REGS MODS 22/00392/B/R

TITLE
installation of velux windows
two storey rear extension, garage
new boundary wall and gate
Bank House Farm, Barnsley Road
Silkstone S75 4FZ
CLIENT Mr C Carr

DRAWING No.
c/21/P3

first floor plan

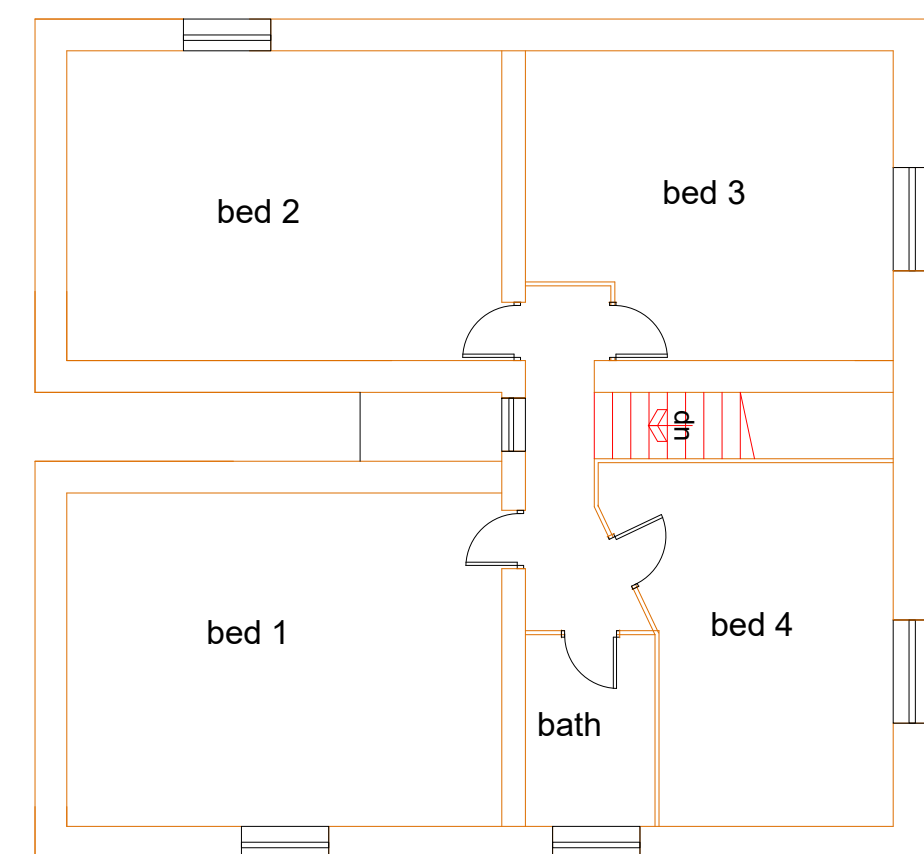
4. An heat detector should be installed in the kitchen in place of the smoke alarm. INDICATED

**southwest (front) elevation**

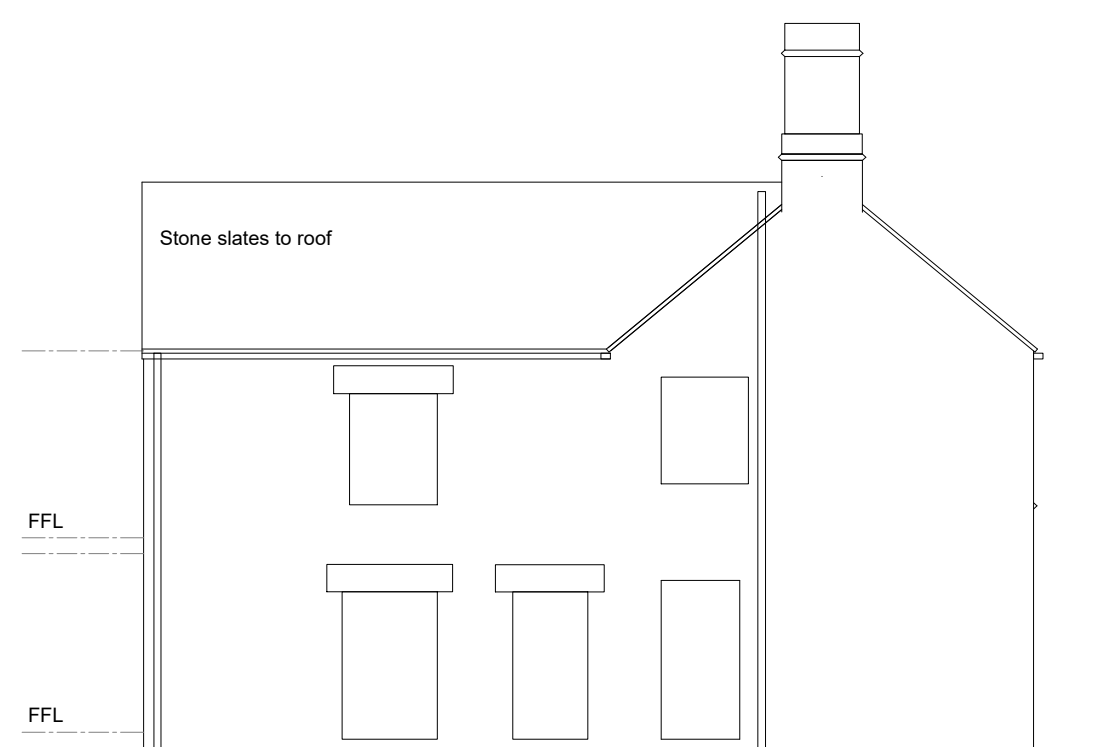
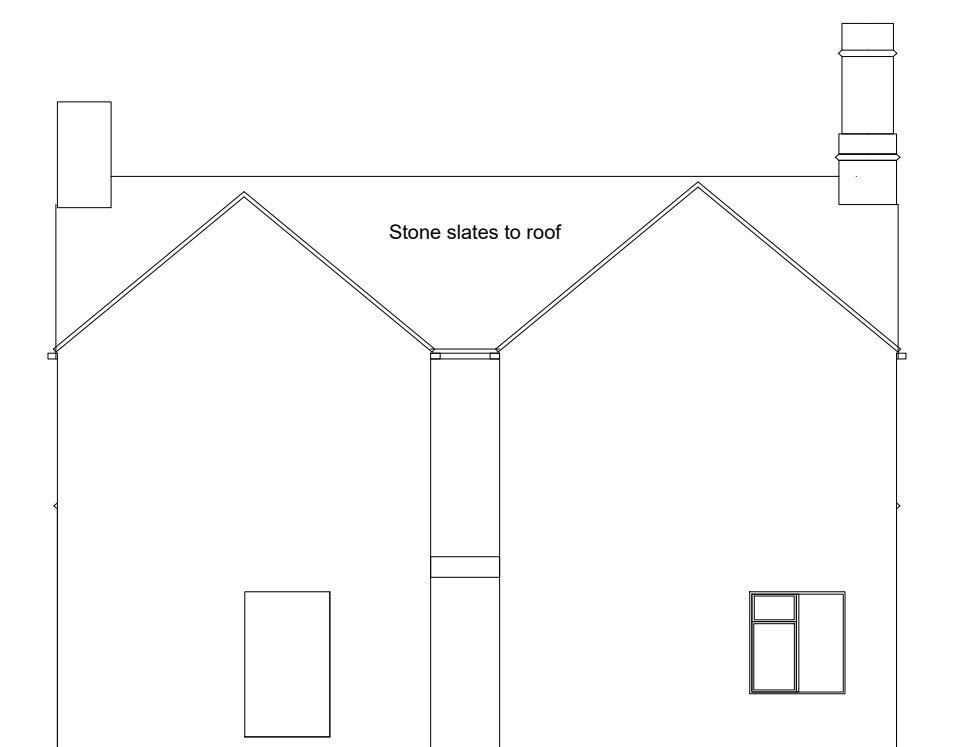
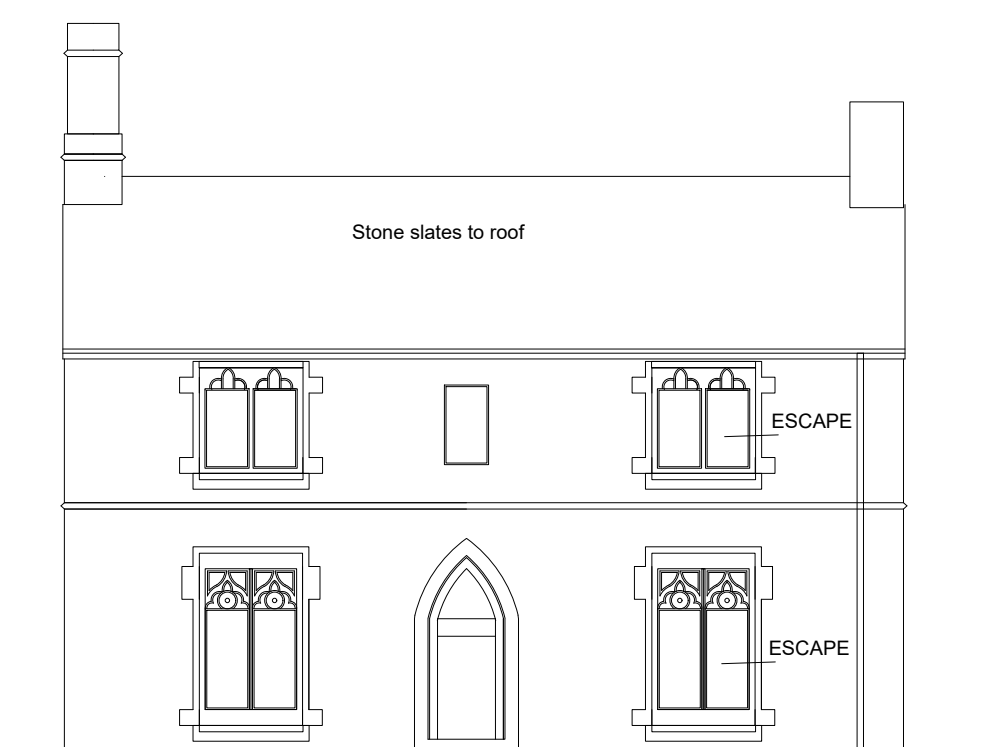
7. The escape window in bedroom 4 is not shown on the elevation drawing. NOW INDICATED
